# Access Compliance Report Public Rights-of-Way (Curb Ramps)

Main Street: RAVENCREST\_RD Cross Street: CARLISLE\_RD Location: N

ADA ID: RPRK211008140423 Ramp Type: Type 1 - Perpendicular Diagonal Initial Pass/Fail: Fail Overall Compliance: No Severity Score: 45

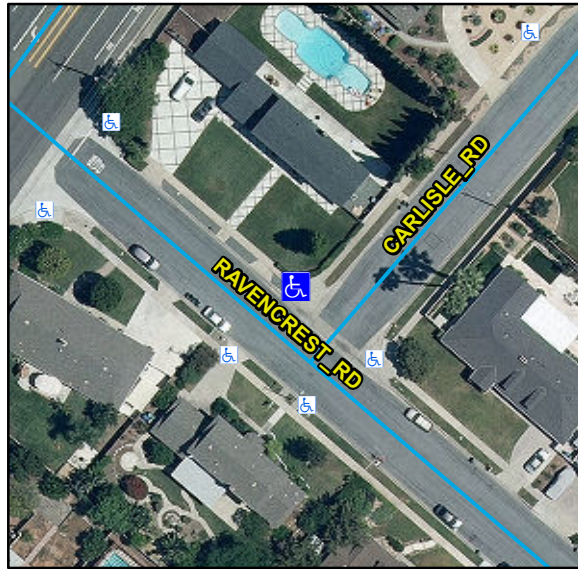
| Compliance | Description                           | Data | Compliance | Description                   | Data |
|------------|---------------------------------------|------|------------|-------------------------------|------|
| No         | Ramp Run Slope (%)                    | 13   | N/A        | Flare Slope LT (%)            | N/A  |
| No         | Ramp Cross Slope (%)                  | 6.3  | N/A        | Flare Traversable LT          | N/A  |

Remove & Replace Curb Ramp With Two New Directional Ramps or Equivalent. Replace Spandrel.
